Legislation Details (With Text)

**File #:** 21-18      **Version:** 1      **Name:**

**Title:** PROPOSED ORDINANCE 21-18 - AN ORDINANCE CREATING SECTION 12-2-25 OF THE CODE OF THE CITY OF PENSACOLA, PROVIDING FOR THE CRA URBAN DESIGN OVERLAY DISTRICT

**Table 12-2-25.3 -Single Family Detached and Two-Family Attached (Duplex) Residential Building Types- R-1AAA through R-1A**

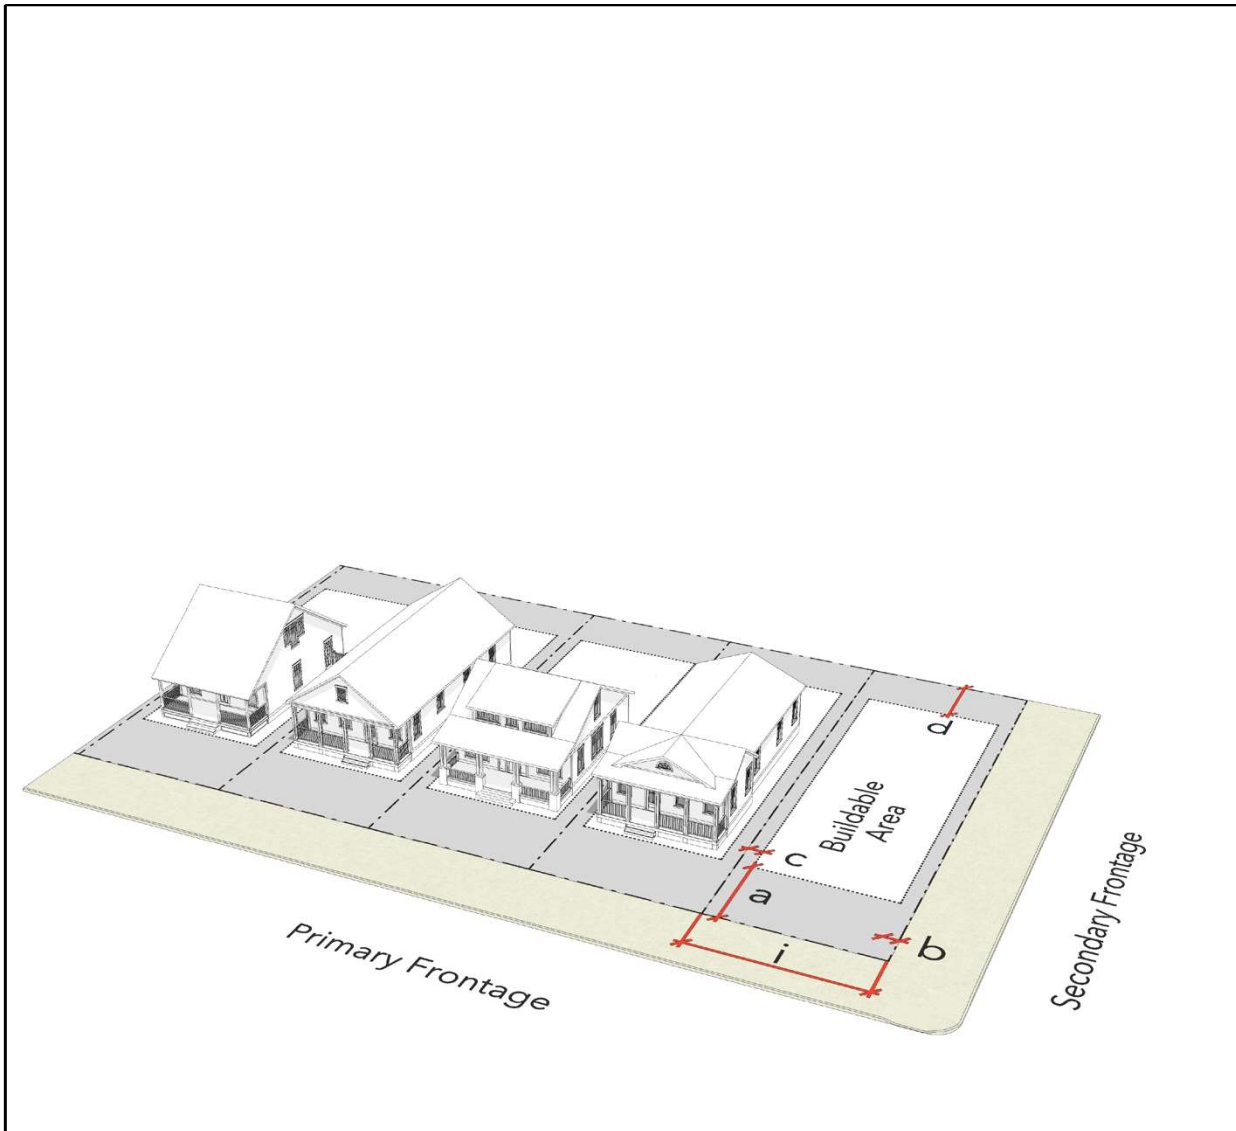
- c. Side and rear setbacks for single family detached and duplex developments on thirty-foot (30') lots should be reduced as follows:
  - a. Side setback reduction from five (5) feet to three (3) feet for single family detached and duplex buildings (Tables 12-2-25.3 and 12-2-25.4).
  - b. Rear setback reduction from 25-30' to 20' for single family detached and duplex buildings (Tables 12-2-25.3 and 12-2-25.4).

a	Front	20 min.
b	Front, Secondary	5 min.
c	Side (Interior)	45 min.
d	Rear	30 min. / 20 min.

- (1) Measured according to Section 12-2-25(G)(a)(c).
- (2) See Section 12-2-25(G)(h)(b) for exceptions.
- (3) Lot width shall only be measured from the right-of-way line. Lot width at the building setback
- (4) [Minimum side yard setback for thirty-foot \(30'\) lots shall be three \(3\) feet measured from the required per applicable Florida Building Code.](#)
